Title		
Size	Number	Revision
A4		
Date:	2018-05-20	Sheet of
File:	C:\Users\...\pay-optical.SchDoc	Drawn By:

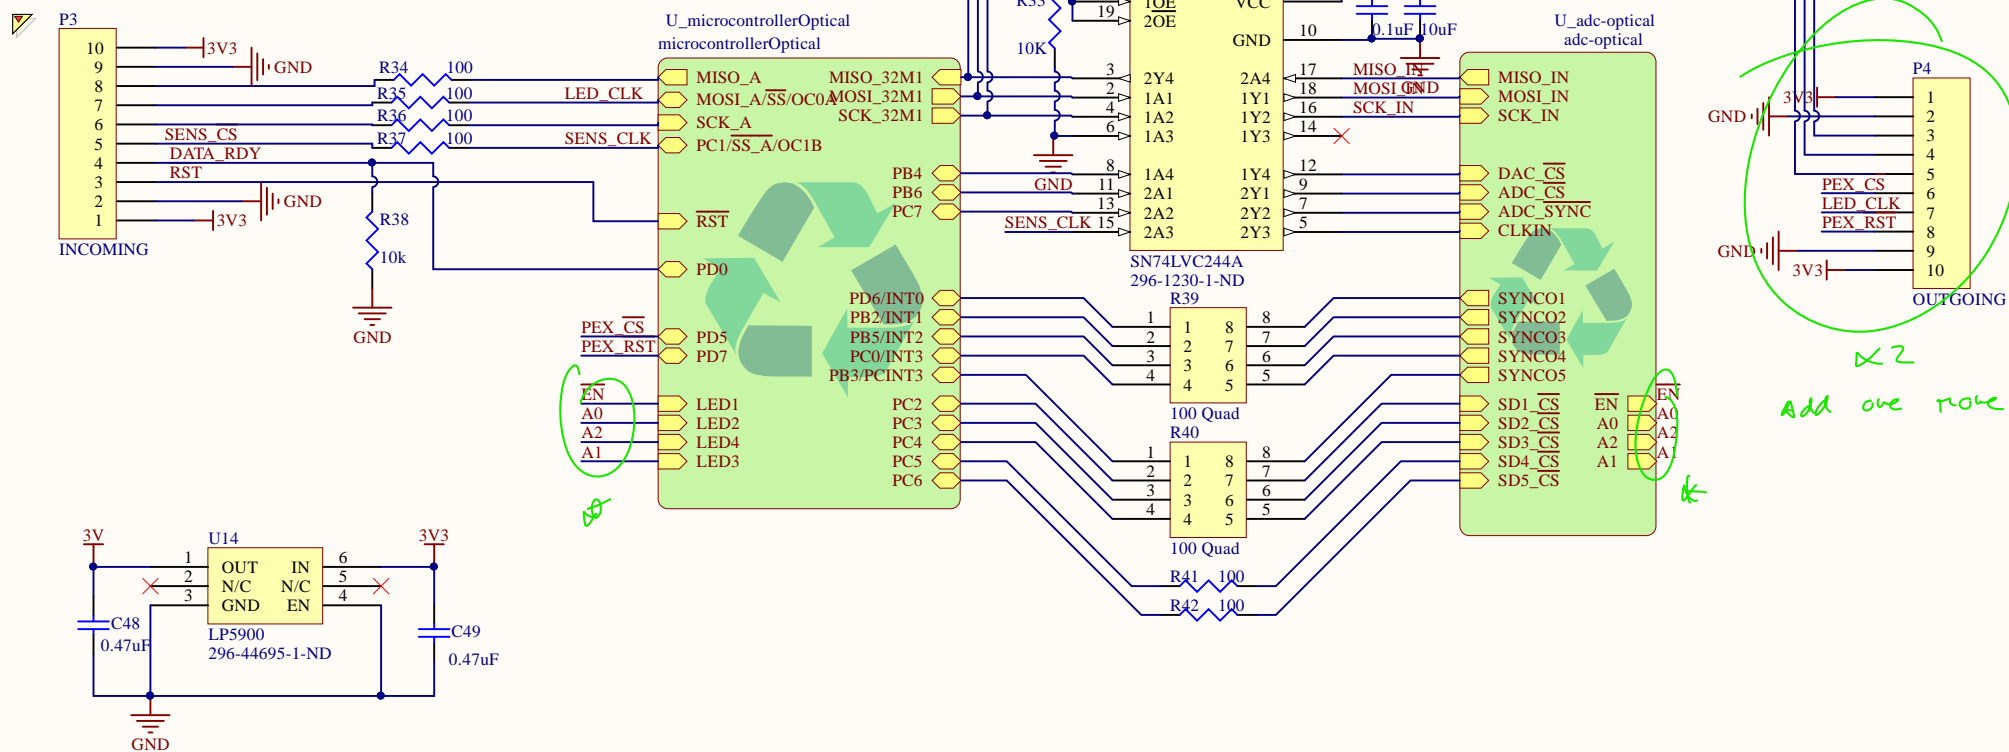
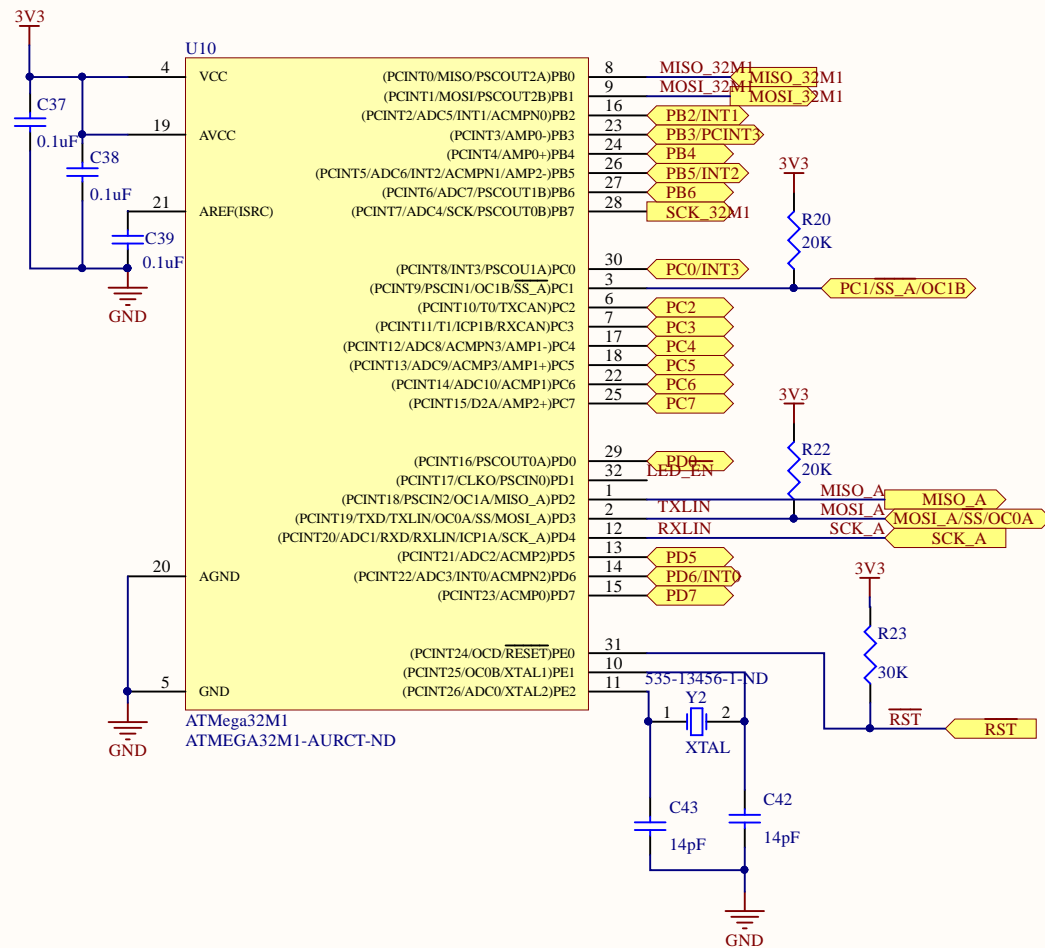
LIMIT RESISTORS PROTECT SSM
THAT SAID, WOULDN'T BE A BAD IDEA TO SET SSM TO INPUT

COMMANDS SEND TO SPI_A

Title		
Size A4	Number	Revision
Date:	2018-05-20	Sheet of
File:	C:\Users\...\microcontrollerOptical.SchDoc	
	Drawn By:

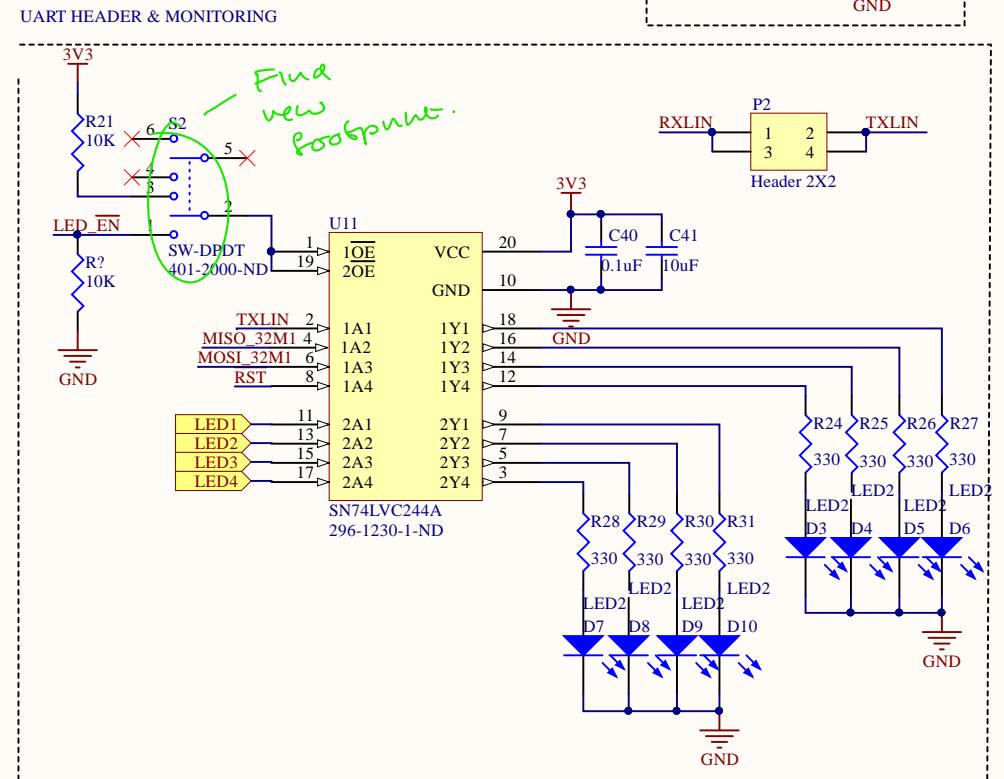
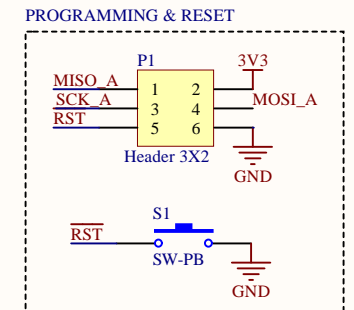
- Add small footprints for programming, debugging
- Connect new LED driver and connect disable switch
- Connect MUX monitoring to new header
